Discussion of:

"Design Process of Deep Soil Mixed Walls for Excavation Support"

by Casandra J. Rutherford, Giovanna Biscontin, Demetrious Koutsoftas, and Jean-Louis Briaud

Thomas D. Richards, Jr, *Chief Engineer, Nicholson Construction Company, 12 McClane Street, Cuddy, PA 15031; email: TRichards@NicholsonConstruction.com*

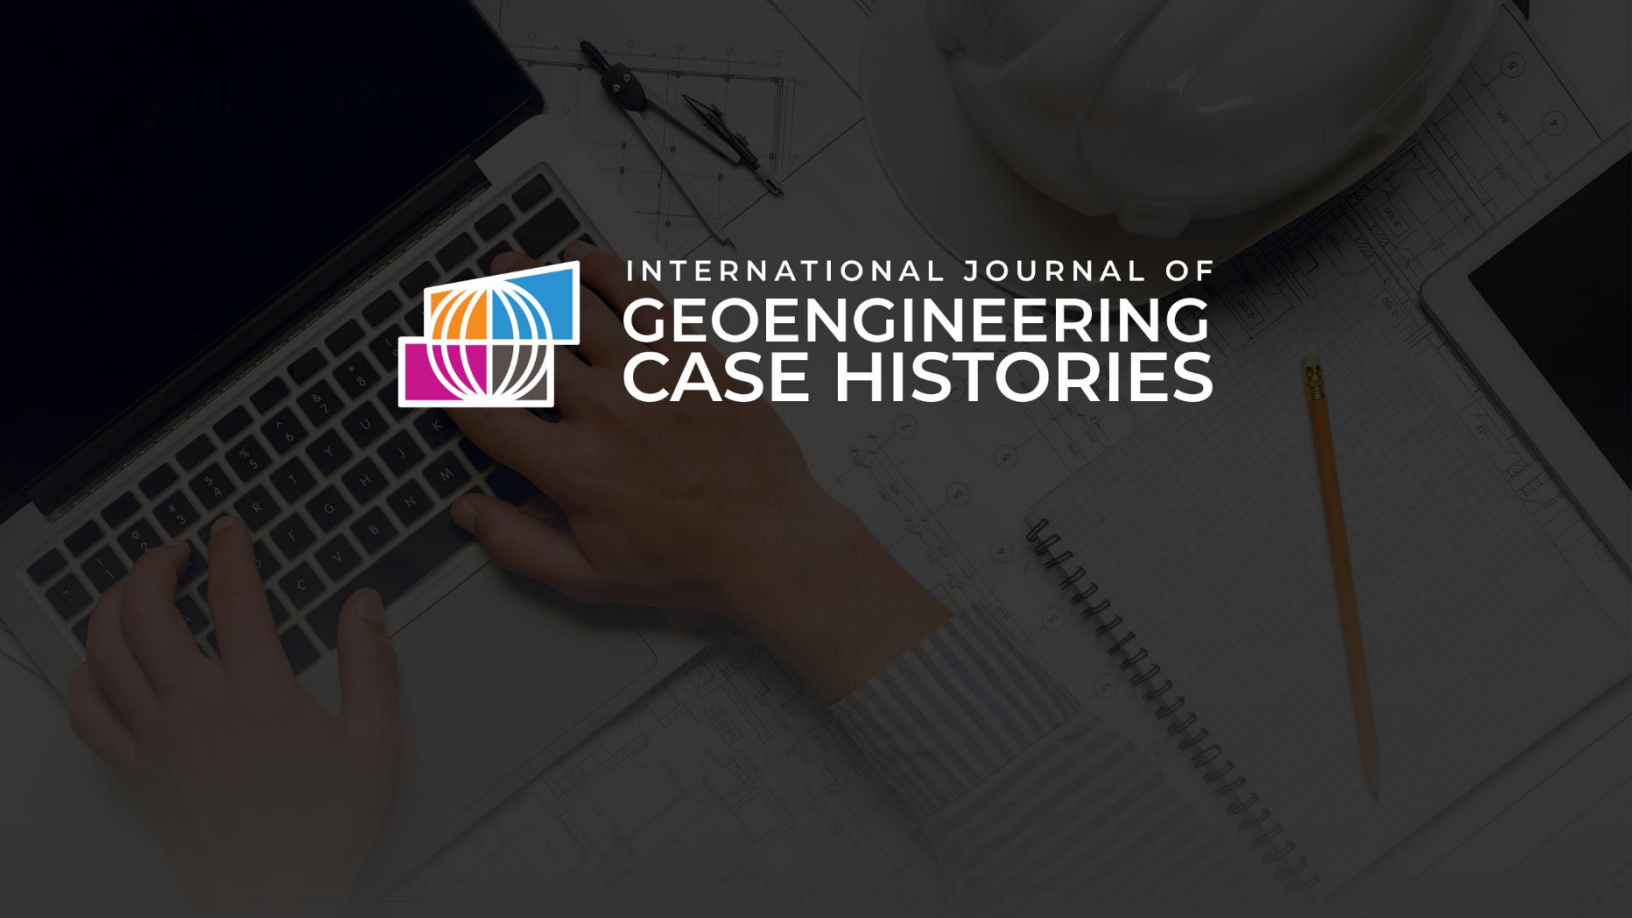
2. Errors in Formula on Figure 15. The ACI method presented in the paper is a possible and probably conservative way of looking at shear resistance. However, the term "b_w" should be a unit vertical height and definitely not the clear distance between the beams. This clear distance between the beams has nothing to do with shear resistance, but does affect the applied shear. The use of b_w equal to the clear space is very unconservative. A better solution is to eliminate the b_w term as follows:

Note that the second 2 in the denominator has the units of psi$^{0.5}$. Also, note that the b_w term cancels out and is no longer in the equation.

Using λ of 0.75 is equal to factor of safety of 1/ λ = 1.33. This seems low but given the conservative concrete beam model may be appropriate.

Also, the term "d" should only extend to the excavated face of the beams.

$$V_{\max} = p \cdot L_2 \cdot b_w$$

Where:
p is the maximum earth pressure;
L2 the clear distance between flanges; and
bw is a unit depth.

$$V_c = \lambda \cdot 2 \cdot f_c^{0.5} \cdot b_w \cdot d$$

$$2 \cdot V_c > V_{\max} \quad \textit{from sum of forces}$$

$$2 \cdot (\lambda \cdot 2 \cdot f_c^{0.5} \cdot b_w \cdot d) > p \cdot L_2 \cdot b_w$$

$$\Rightarrow f_c^{0.5} > (p \cdot L_2 \cdot b_w) / (2 \cdot (\lambda \cdot 2 \cdot b_w \cdot d))$$

$$\Rightarrow f_c^{0.5} > (p \cdot L_2) / (2 \cdot (\lambda \cdot 2 \cdot d))$$

$$\Rightarrow f_c > [(p \cdot L_2) / (2 \cdot \lambda \cdot 2 \cdot d)]^2$$
